REVISED 7/8/2024 STAFF REPORT: 7/10/2024 MEETING PREPARED BY: J. ROSS

ADDRESS: 1108 VAN DYKE

APPLICATION NO: #HDC2024-00355

SCOPE: DEMOLISH GARAGE; ERECT GARAGE; REHABILITATE DWELLING

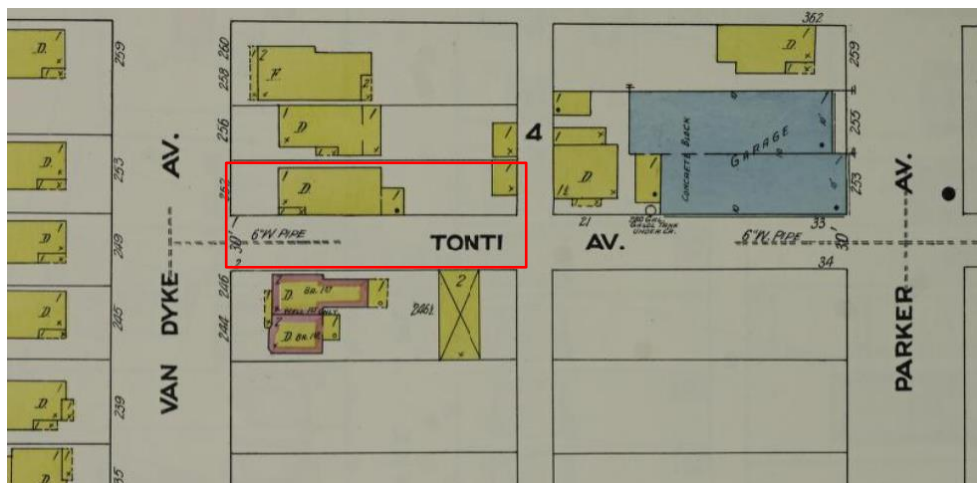
- The application is proposing to replace the current deteriorated stucco clad brick base at the north elevation projecting sunporch bay with new concrete foundation. Staff supports this proposal with the condition that any portion of the foundation that is above grade is clad with stucco/it has an appearance that is consistent with the rest of the home.

- The above-grade portion of the rebuilt projecting sunporch bay's new concrete base shall be clad with stucco and painted so that it has an appearance that is consistent with the rest of the home.

1108 Van Dyke, facing southeast, showing honey locust tree proposed for removal. Staff photo taken on 6/25/2024

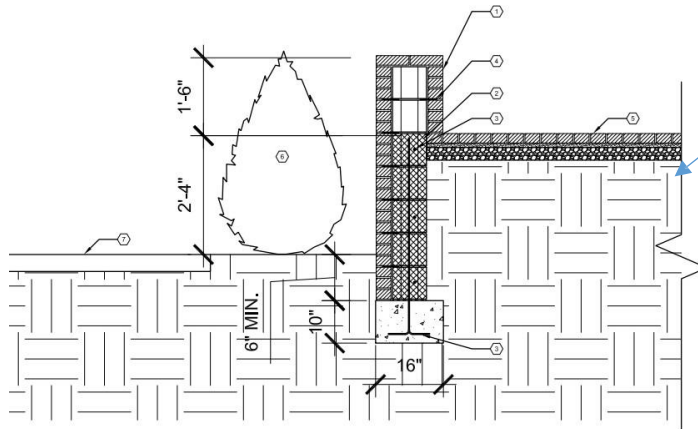
- A third tree (see below photo), located to the west at Van Dyke of the building, is proposed for removal. Staff notes the following re: this tree:
 - The applicant has submitted a statement from an arborist which notes that the tree has a DBH of 40" and its "...very close to foundation and large portion of tree over roof. The tree has a history of failure. The main stem is covered with a vine. The

tree is nearing the end of its life cycle and should be removed to protect the historical structure/ house”. Staff estimates that the tree is 15’ west of the house

- A review of the property’s designation slides indicate that the tree was present in 1983. The HDC staff landscape architect reviewed photos of the tree and has estimated that the tree is 70 years old. He also noted that the arborist statement does not clearly state that the tree is in poor health/dead/diseased and stated the following:

The tree’s canopy appears healthy with no major dead branches (maybe some smaller minor ones). The lean over the house is a potential future problem if the canopy or trunk shows sign of damage and disease, but I see no sign of that. The tree could be limbed up in areas over the house. The roots are well established and will not pose a future danger to the house unless there are signs of damage occurring now, which no evidence has been shown. It’s true that a tree of this species usually does not live past 100 but until there are signs of damage or health conditions to this particular tree, regular maintenance can be done to prevent damage. Besides trimming branches, the ivy could be removed to preserve the longevity of the tree.

- Staff therefore recommends that the tree be retained as it is an historic, distinctive character-defining feature of the property/landscape. However, if the Commission does approve its removal, staff recommends that a new compatible shade tree be planted on the property or the adjacent parcel/1116 Van Dyke to maintain the neighborhood’s historic canopy.

- It is staff's opinion that the historic-age honey locust tree to the west of the house that is proposed for removal is a distinctive character-defining feature of the property/landscape. As it is not currently dead or diseased and can be limbed to ensure that its branches do not hang over the house, it is staff's opinion that its removal would not meet the Standards.

- The historic-age honey locust tree to the west of the house is a distinctive character-defining feature of the property/landscape. As it is not currently dead or diseased and can be limbed to ensure that its branches do not hang over the house its removal would not meet the Standards
- The yard's sloping terrace is a distinctive, character-defining feature of the property/landscape. The new patio, retaining wall and shrubs will destroy the terrace's gentle, organic slope which currently exists at the west property line as the area behind the retaining wall will be to even out the surface of the patio area. This graded area would change the current sloping terrace to raised flat patio, altering the landscape and giving the lawn an incompatibly more formal appearance when the property/yard is viewed from Van Dyke Street.

1 PATIO DETAIL SECTION
SP1.1 SCALE: 1/2" = 1'-0"

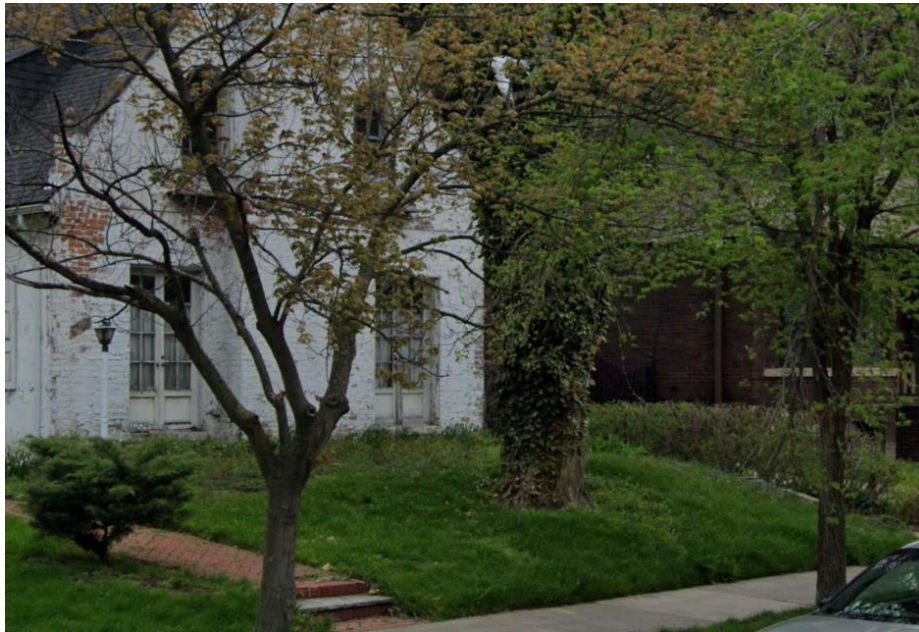
- The applicant further proposes to install a new brick paver patio, masonry retaining wall and shrubs beyond to the west of the new patio. As noted previously, the yard's sloping terrace is a distinctive, character-defining feature of the property/landscape. The new patio, retaining wall and shrubs will destroy the terrace's gentle, organic slope which currently exists at the west property line (primary expression facing Van Dyke) as the area behind the retaining wall will be to even out the surface of the patio area. This graded area would change the current sloping terrace to raised flat patio, altering the landscape and giving the lawn an incompatibly more formal appearance when the property/yard is viewed from Van Dyke Street. It is staff's opinion that this work item does not meet the Standards.

- As noted previously, the yard's sloping terrace is a distinctive, character-defining feature of the property/landscape. The new patio, retaining wall and shrubs will destroy the terrace's gentle, organic slope which currently exists at the west property line as the area behind the retaining wall will be to even out the surface of the patio area. This graded area would change the current sloping terrace to raised flat patio, altering the landscape and giving the lawn an incompatible more formal appearance when the property/yard is viewed from Van Dyke Street. It is staff's opinion that this work item does not meet the Standards.
